Voltage and resistance measurements for the KWM-2/2A Transceiver are located in the service instructions section of this instruction book.

# SCHEMATIC CHANGES AND EQUIPMENT DIFFERENCES

KWM-2 and KWM-2A Transceivers, Schematic Diagram  
Figure 7-1 (Sheet A)

KWM-2 and KWM-2A Transceivers, Schematic Diagram  
Figure 7-1 (Sheet D)

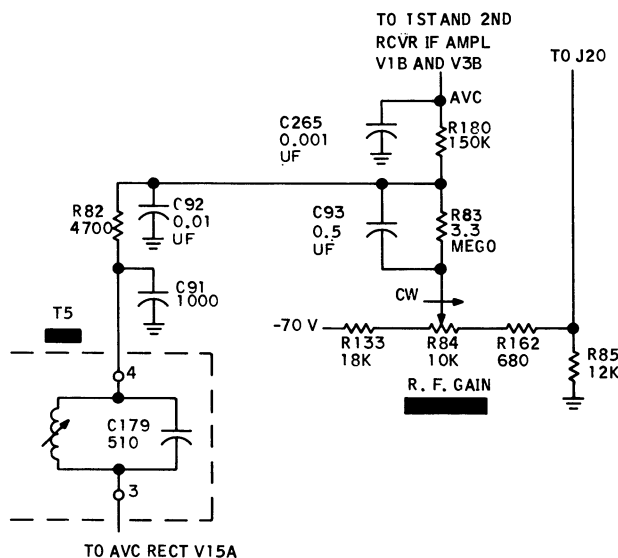
13	R198, 27 k $\Omega$ , is in some units. This resistor was added to reduce if leakage, but then removed to improve if gain. If this component is in the unit, it need not be removed. Some early units have mechanical filter FL1 (part number 526-9337-00). Later units have mechanical filter FL1 (part number 526-9427-000). The two types of mechanical filters are electrically the same but physically different. It is recommended that this component be replaced with same part numbered component. To replace the older mechanical filter (part number 526-9337-00) with the newer one (part number 526-9427-000) bracket having part number 544-9714-002 must be replaced with a bracket having a part number 606-9731-001. Bracket part number 606-9731-001 has a clip to hold the mechanical filter.
(Cont)

KWM-2 and KWM-2A Transceivers, Schematic Diagram  
Figure 7-1 (Sheet G)

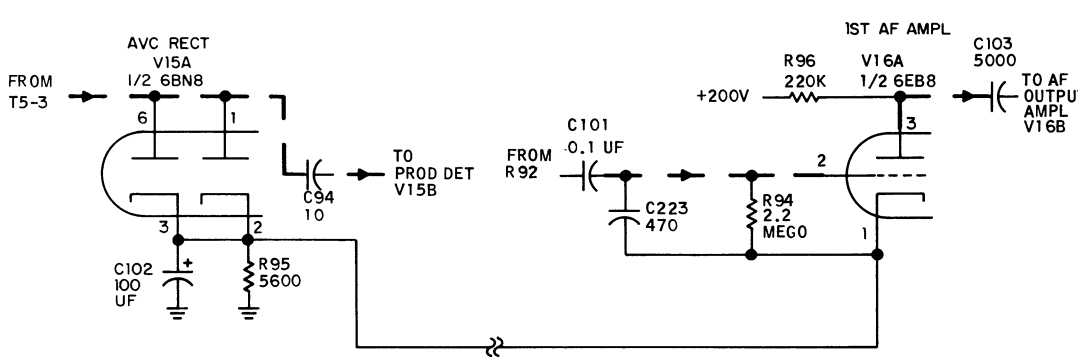
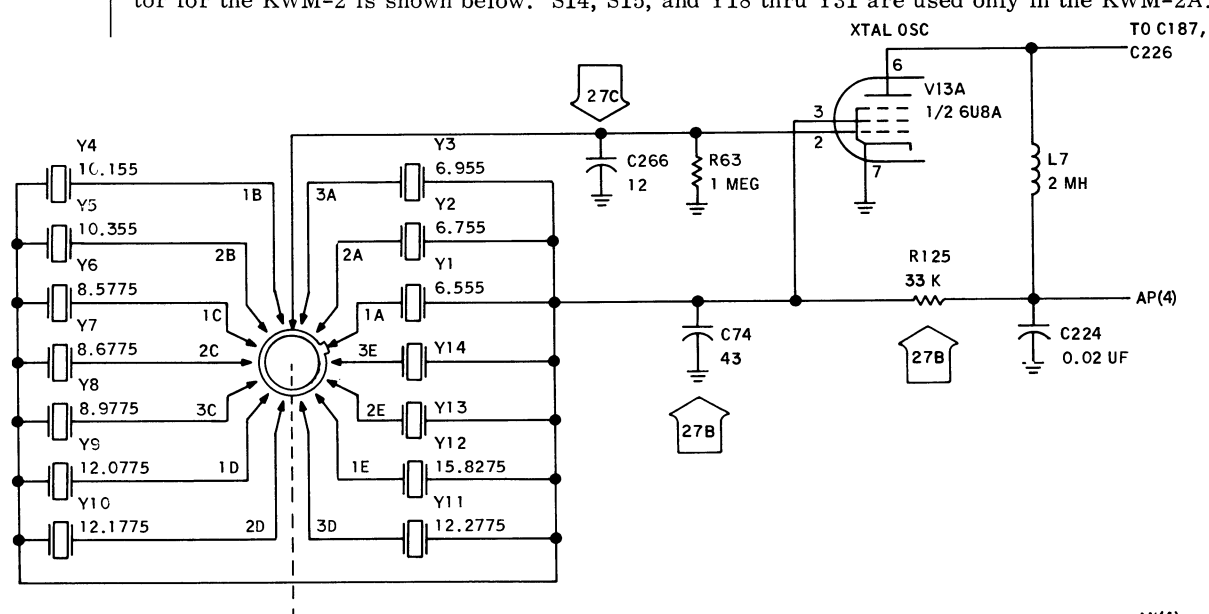
IDENTIFIER	DESCRIPTION
26	<p>Many units have an AVC rectifier bias circuit as shown below. This circuit has been changed to the configuration shown on the schematic to prevent low-frequency audio detection by the AVC rectifier, therefore an audio output, when the AF GAIN control is set at minimum. If repairing the circuit shown below, recommend that same configuration be maintained.</p>  <p>Changes made to the circuit above to produce the circuit shown on the schematic are as follows: R210, 620 k<math>\Omega</math>, added; C275, 0.01 <math>\mu</math>F, added; and cathode of V16A disconnected from cathode V15A and grounded. Reference part B of service bulletin no 8.</p> <p>27</p> <p>R213, 2.2 megohms; CR11, 1N458; and C276, 0.05 <math>\mu</math>F, added. These changes reduce effects of strong adjacent channel SSB signals. If these components are not in the unit, they do not have to be added. Reference part C of service bulletin no 8.</p> <p>27A</p> <p>Y13, Y14, and Y18 thru Y31 are not furnished. These crystals are to be selected by the user.</p> <p>Schematic diagram shows the KWM-2A crystal oscillator configuration. The crystal oscillator for the KWM-2 is shown below. S14, S15, and Y18 thru Y31 are used only in the KWM-2A.</p>

KWM-2 and KWM-2A Transceivers, Schematic Diagram  
Figure 7-1 (Sheet H)

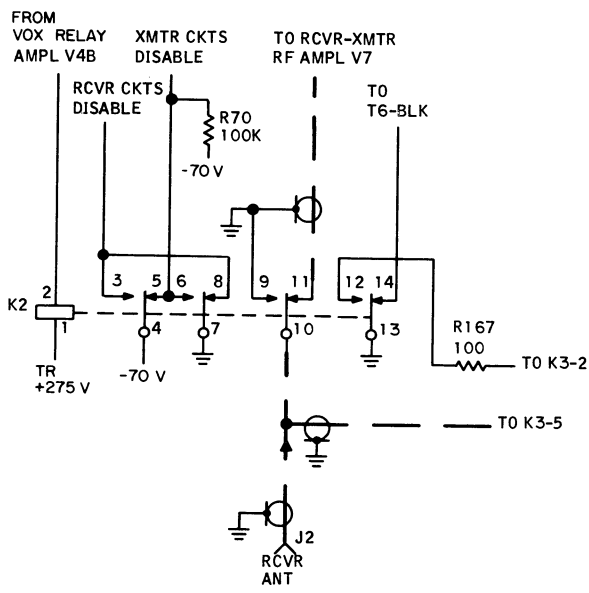
IDENTIFIER	DESCRIPTION
None	Schematic correction, V12B, 6U8A was 6U8.
27B	C74, 43 pF, was 47 pF and R125, 33 kilohms, was 47 kilohms. These changes increase the gain and the feedback of the crystal oscillator. If replacing these components, recommend replacing with the same values removed from your unit. Reference service bulletin no 3 (reissue).
27C	R214, 4700 ohms, was added and R151, 2700 ohms, was 3900 ohms. These changes help equalize crystal oscillator output on all frequency bands. If replacing these components, recommend replacing with the same value removed from your unit.
(see 27A )	C266, 12 pF, was 27 pF. This component found only in KWM-2. This change increases feedback of the crystal oscillator. If replacing this component, recommend replacing with the same value removed from your unit. Reference service bulletin no 3 (reissue).
27D	Changed resistor R125 from 33 k $\Omega$ to 12 k $\Omega$ . Added capacitors: 0.02- $\mu$ F C280, 0.1- $\mu$ F C281; coils: 1-mH L43, 2.2-mH L44; and 1N5383B zener diode CR13. Relocated resistor R125 and capacitor C224 as shown on the schematic diagram. This change improves frequency stability for +12-, +24-, and +28-V dc remote or vehicular operation.

*KWM-2 and KWM-2A Transceivers, Schematic Diagram  
Figure 7-1 (Sheet J)*

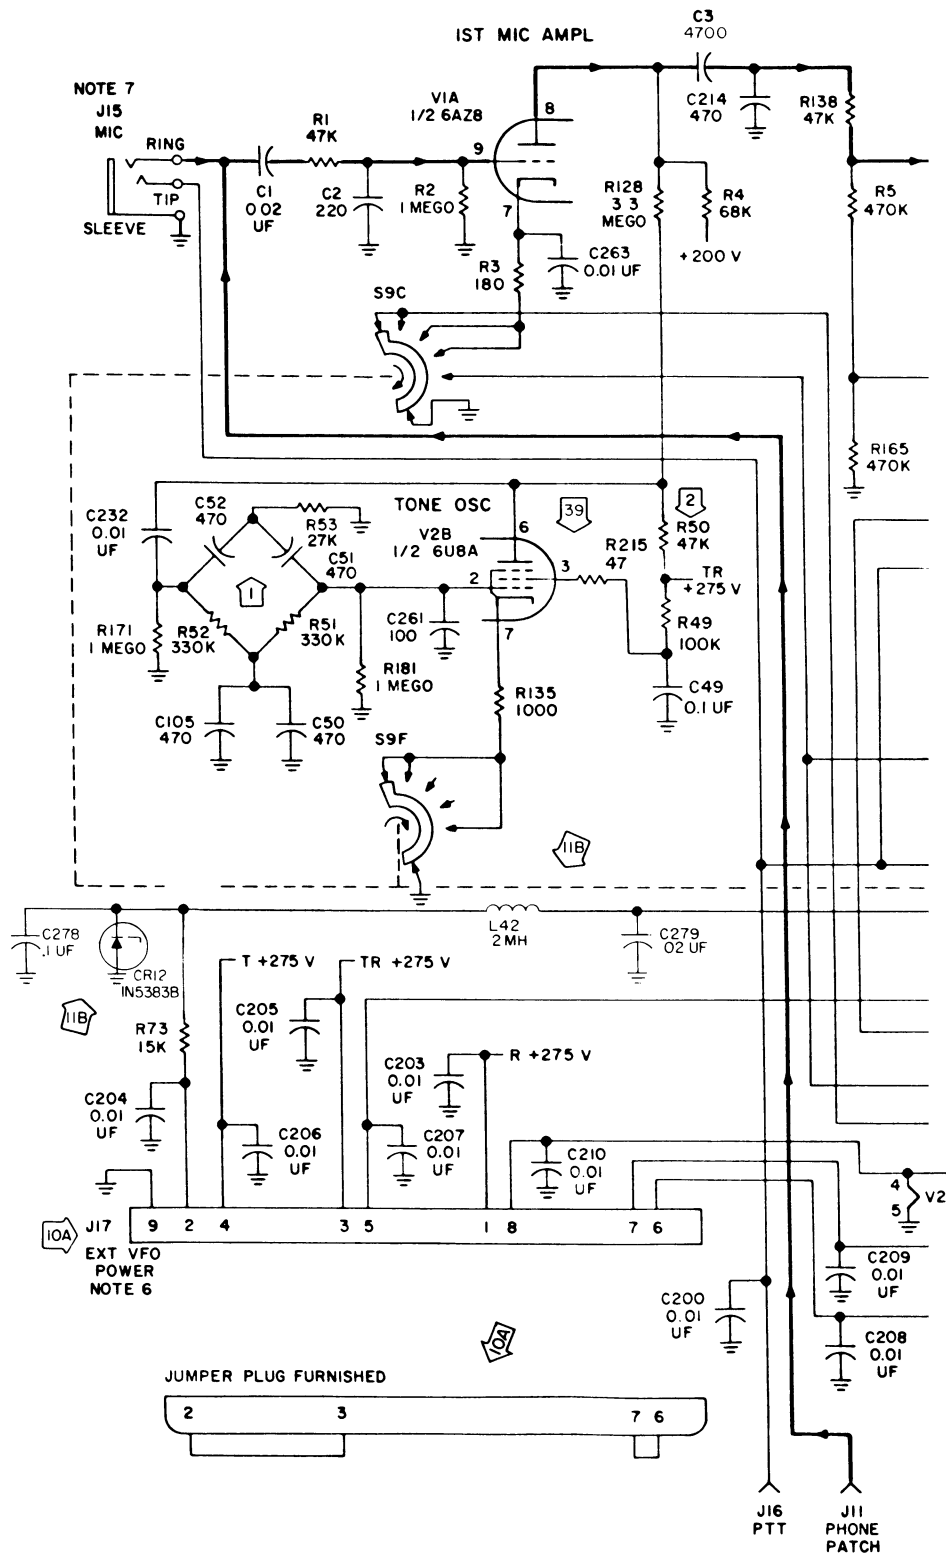
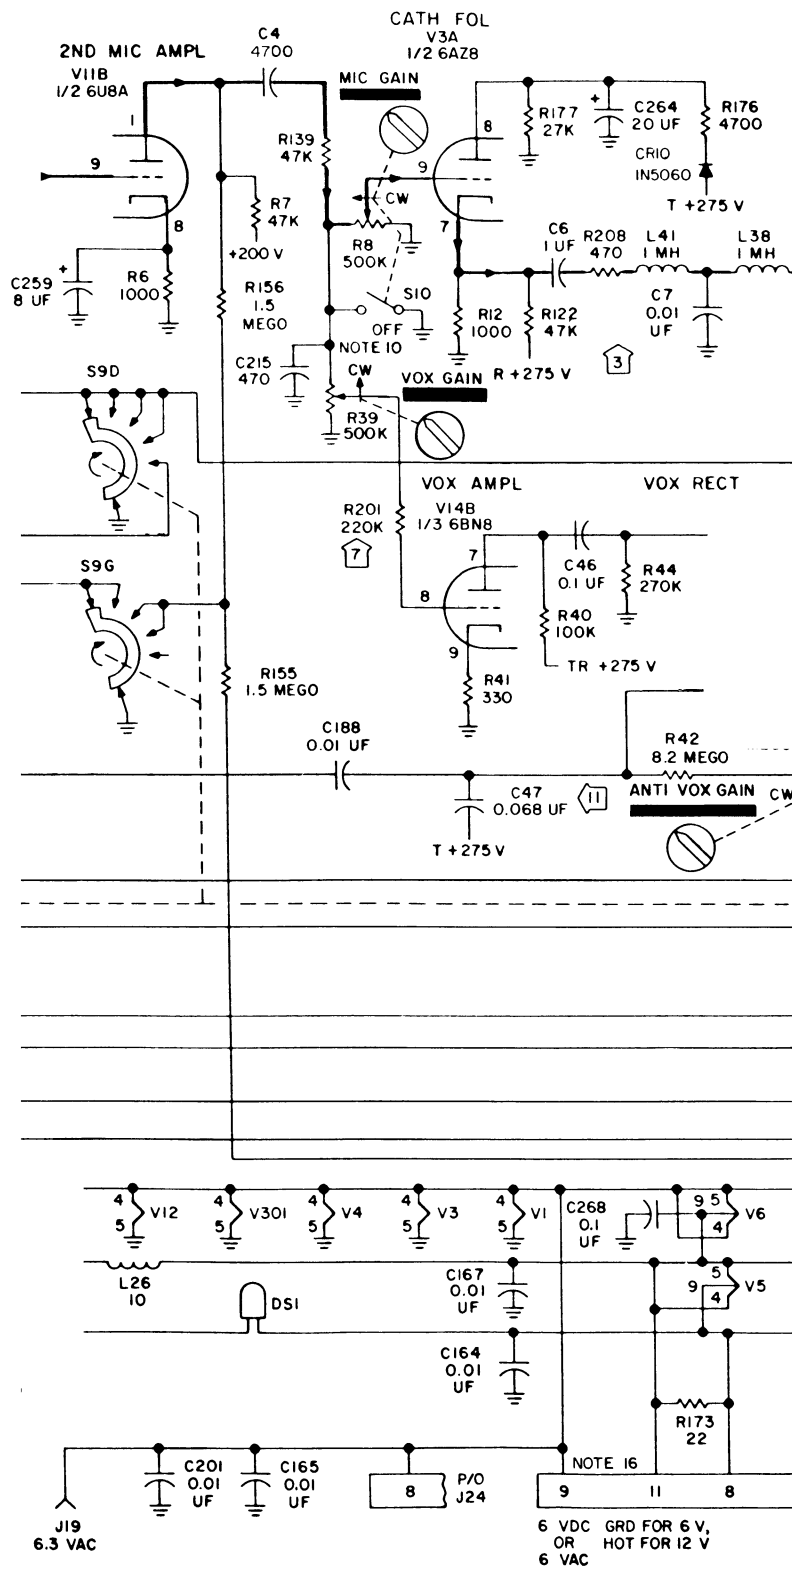
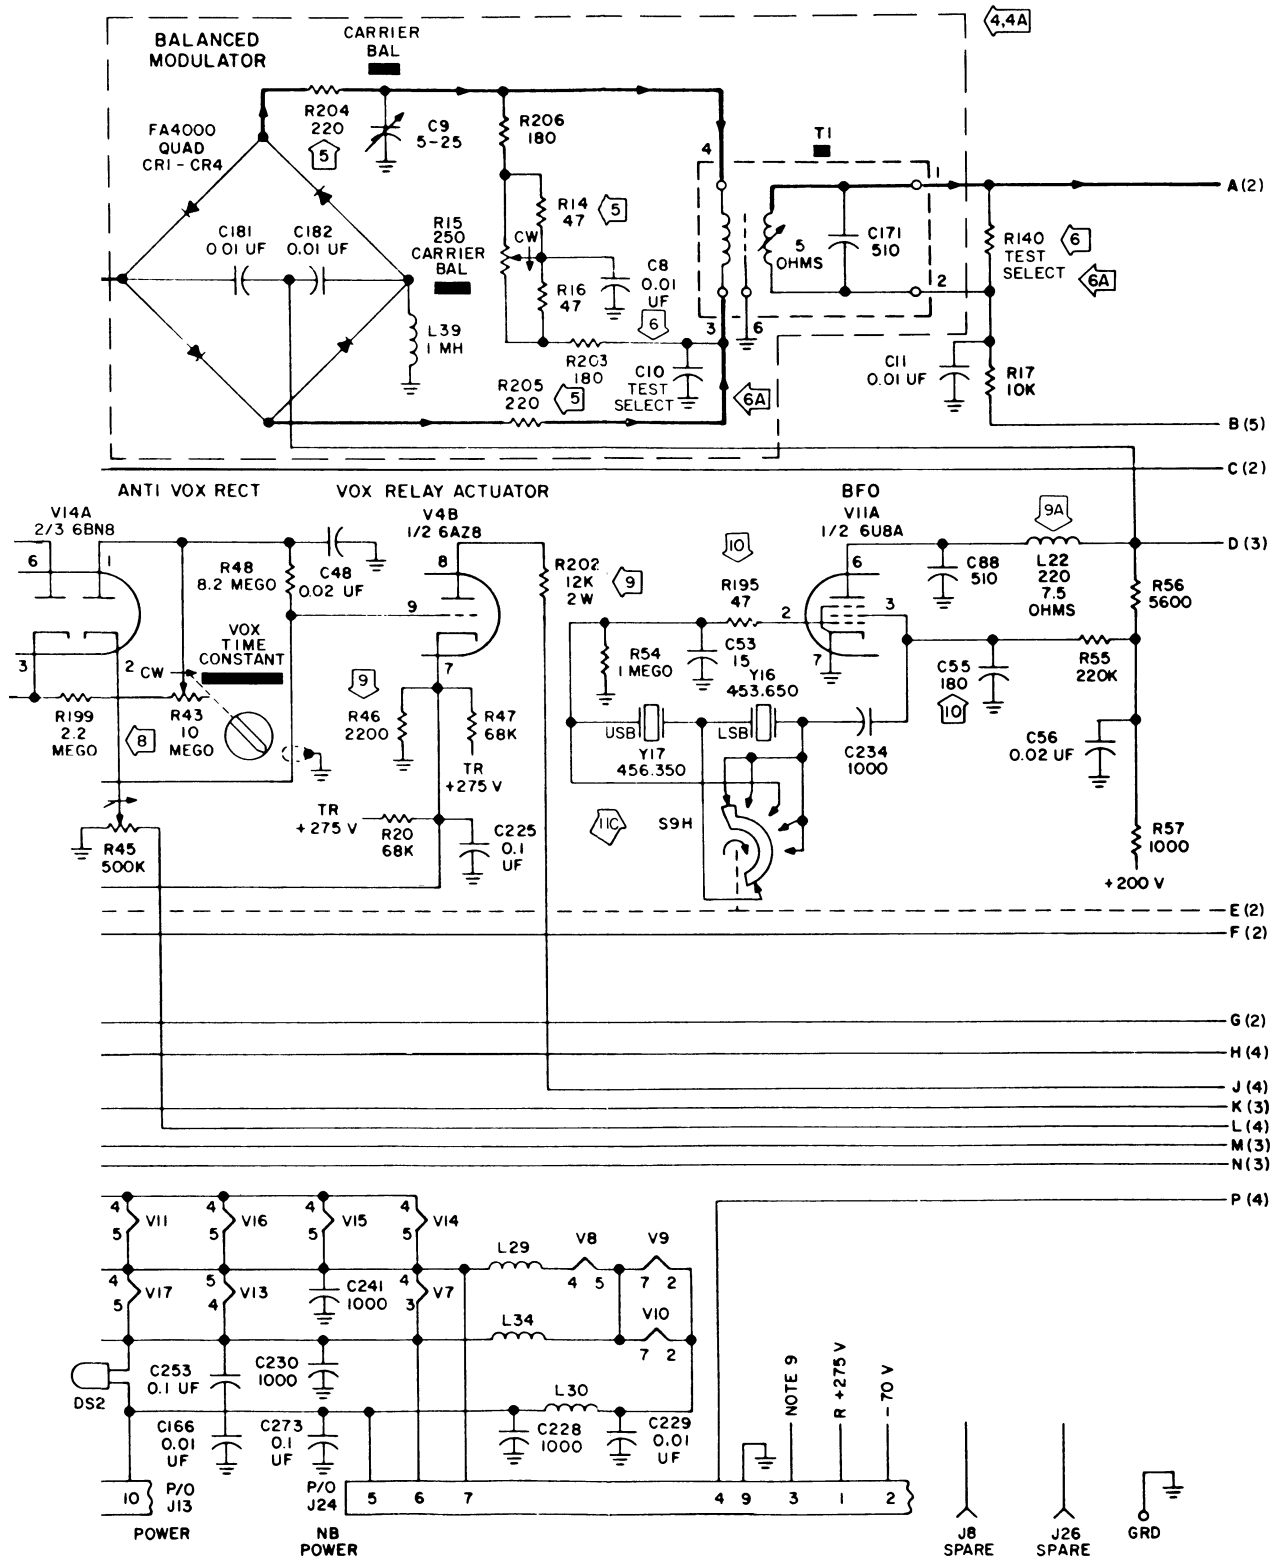
IDENTIFIER	DESCRIPTION
<div data-bbox="139 308 193 405">36 (Cont)</div>	<p>VFO FROM V2A VFO FROM V17B</p> <p>AVC OR ALC TO V7</p> <p>ALC LINE</p> <p>METER SHUNT R158</p> <p>ALC-GRID-PLATE SW S12 METER SHUNT R158</p> <p>ALC-GRID-PLATE SW S12 TO K3-1</p> <p>TO K3-2</p> <p>C211 0.1 UF</p> <p>R157 68</p> <p>R86 2500</p> <p>C106B 30</p> <p>+200 V</p> <p>C108 0.01 UF</p> <p>R101 47</p> <p>T0 J13-7</p> <p>T0 J13-6</p> <p>Corrected schematic diagram error. Connector J26 was inadvertently called J28.</p> <p>R211, 470 ohms, added and R190, 1500 ohms, was 2200 ohms. These changes shift the ALC line bias to reduce transmit gain variations between LSB, USB, and CW positions versus TUNE and LOCK positions of the EMISSION control. If repairing this circuit, recommend that same configuration be maintained.</p>
None	Restated all notes.
38	C155, 63- to 320 pF variable capacitor, was 15- to 120-pF variable capacitor. This change improves pa output loading on 15- and 10-meter bands. If replacing this component, recommend replacing with 63- to 320-pF variable capacitor.
